SNUPPS

Standardized Nuclear Unit
Power Plant System

SLNRC 81-95 FILE: 0541
SUBJ: NRC Request for Information-
Mechanical Engineering

Q210.2

Figure 5.4-18

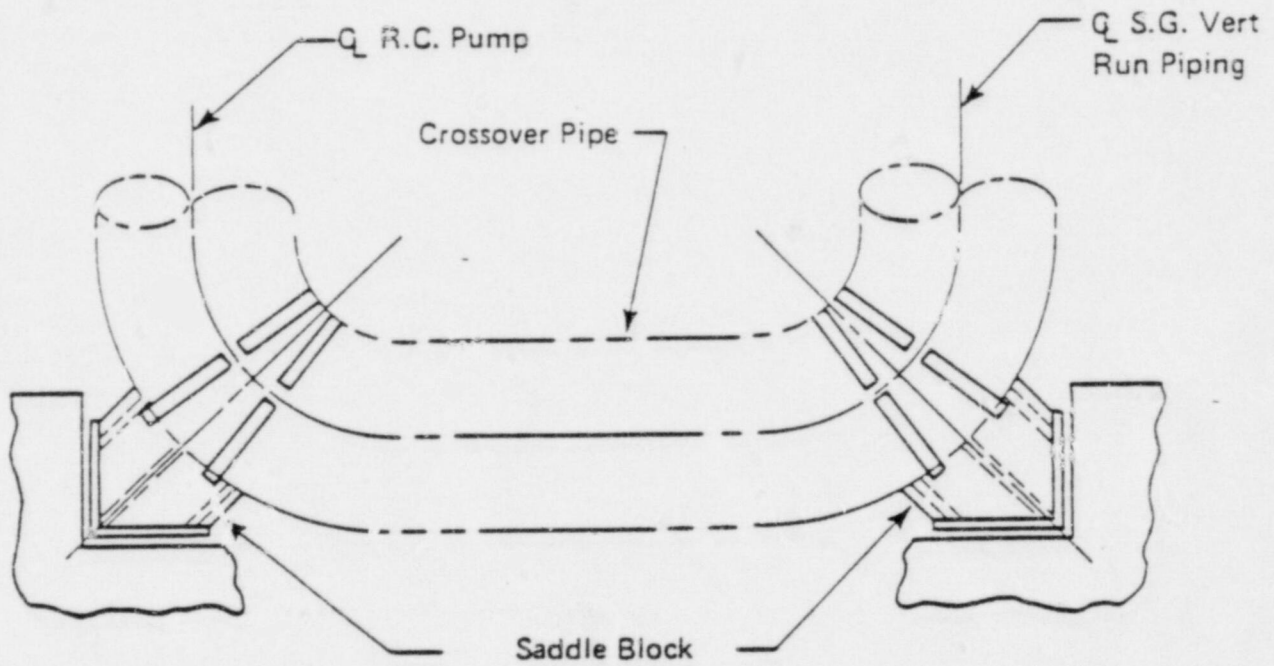
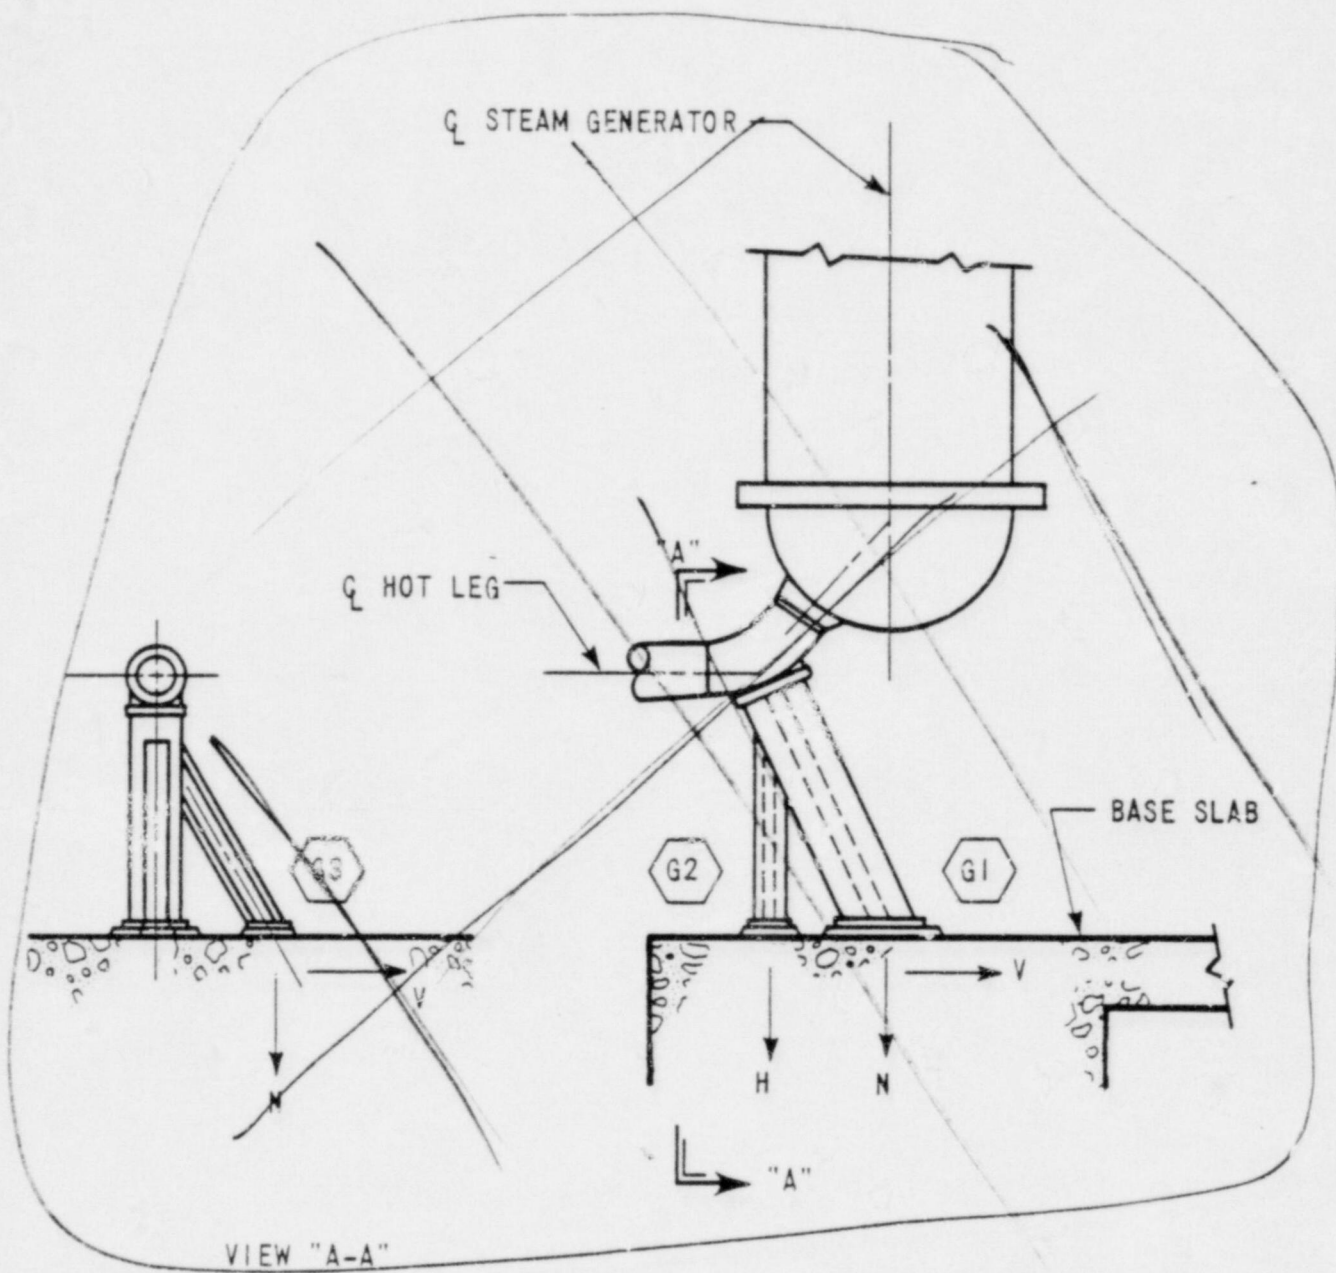
The applicant states that all circumferential breaks in the RCS piping are assumed to result in a limited separation such that the maximum flow area is less than a full break area. The applicant must provide the design information assumed for each location where limited break areas are postulated including gap size, restraint stiffness, blowdown force, and maximum restraint deflection. The results of the time-history analysis (if used) should include the break area vs. time and mass flux rate vs. time which were used to calculate the subcompartment pressurization.

In addition, all restraint locations on the RCS piping must be shown.

Replace with attached
